DESIGN EXCEPTION #DE19-02

To: Mark Relph, Director of Public Works & Utilities
Thru: Tim Moore, Public Works Manager
Copy to: Eric Hahn, Development Engineer
From: Mike McDill, City Engineer
Date: July 11, 2002
RE: Exception from Driveway Width Criteria at 2331 Interstate Avenue

RE: TEDS Exception to Allow a Narrower Driveway at 2331 Interstate Avenue

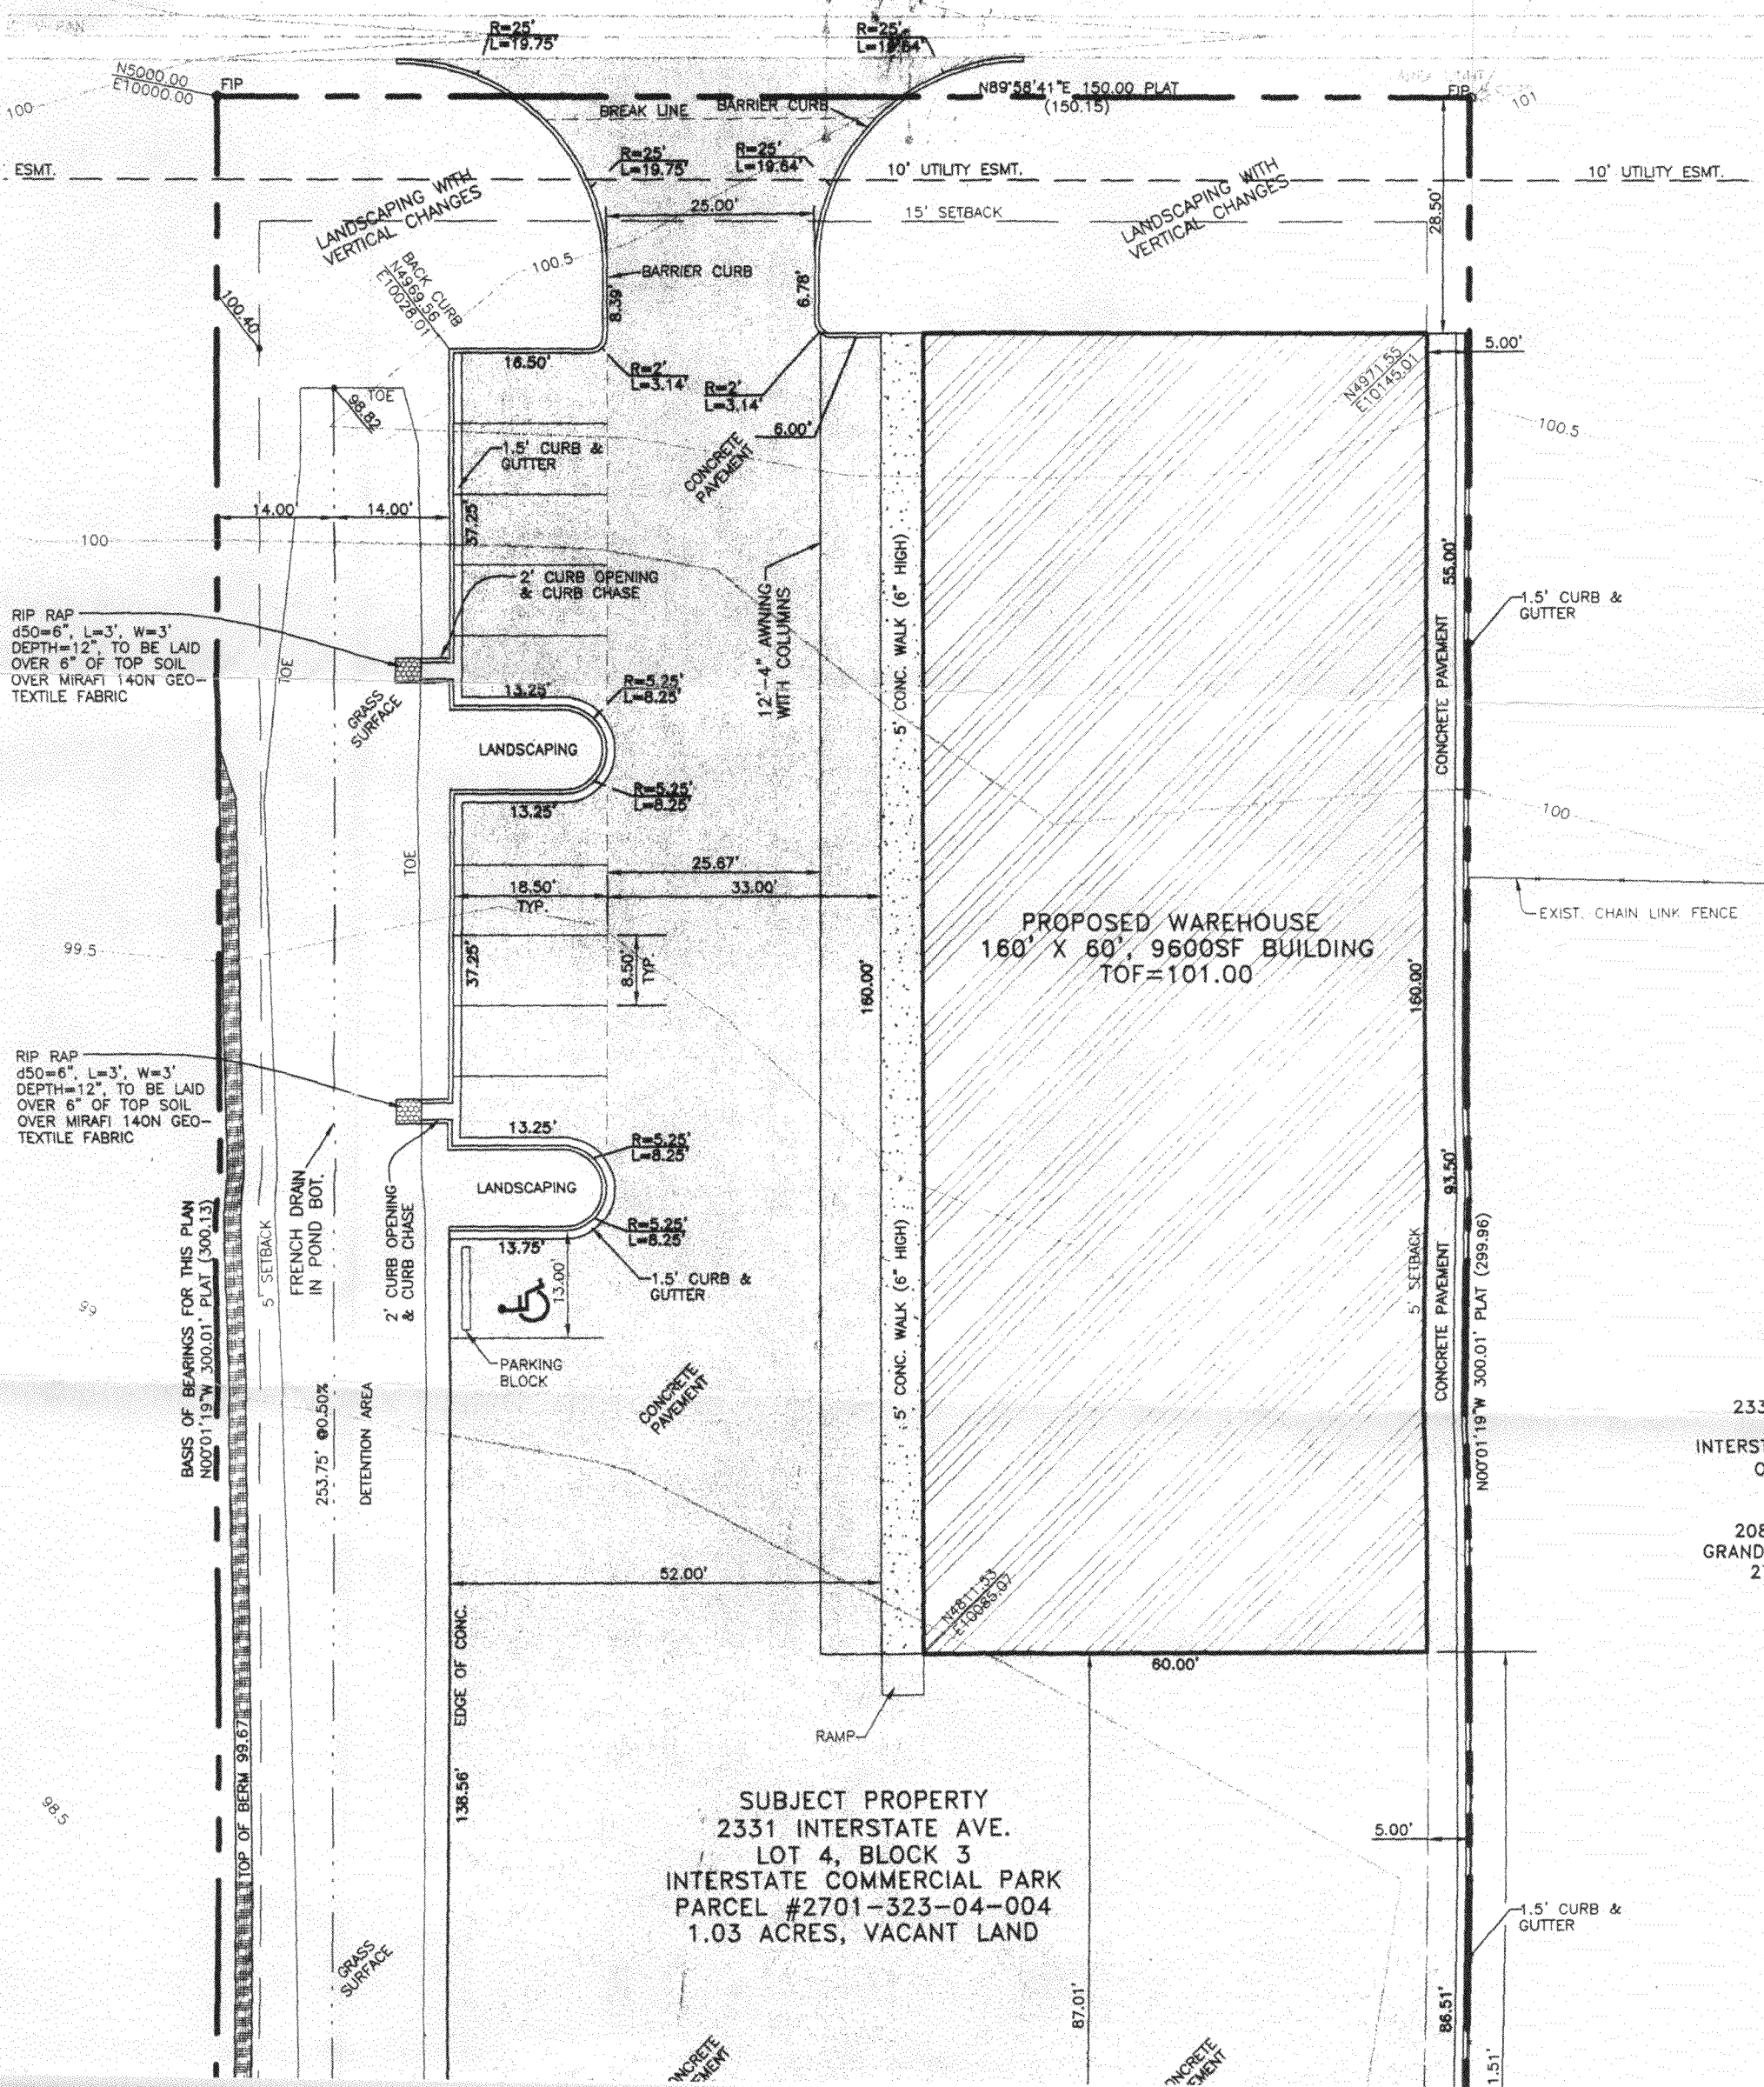
Applicant is planning to construct a building at the above property. They are proposing to construct one 25-foot wide driveway along the south side of Interstate Avenue. Although the applicant does not describe the "unique circumstances," it appears they are constrained by the width of the parking and detention pond on the west and the width of the building on the east. No information was provided to illustrate the detention pond could not be configured differently. It may also be that they are trying to get too much building on this lot.

Along the north side of Interstate Avenue there are existing driveways centered 35 feet west of the west edge and 25 feet west of the east edge of this lot. The only way this lot can meet the criteria of Section 4.1.2, *Offsets*, is to center their driveway directly across from the second driveway described above.

It appears to me that, by flipping the layout (to put the building along the west side and the parking along the east) and incorporating the detention into the parking lot, they can meet their needs and comply with our standards.

I recommend denial of the requested Design Exceptions to Sections 4.2.4 & 4.1.2 to allow a reduced width and spacing between the proposed driveway. Insufficient justification was provided and it appears there are options available to develop this site within the standards.

Staggered driveways at less than 150 foot spacing will not be as safe as driveways that are opposite each other or separated by at least 150 feet.

The Review Committee declined to approve your request for a smaller driveway. They also objected to the location in relation to the two existing driveways on the north side of Interstate Avenue. There appear to be other design options which might allow development of this site within the TEDS.
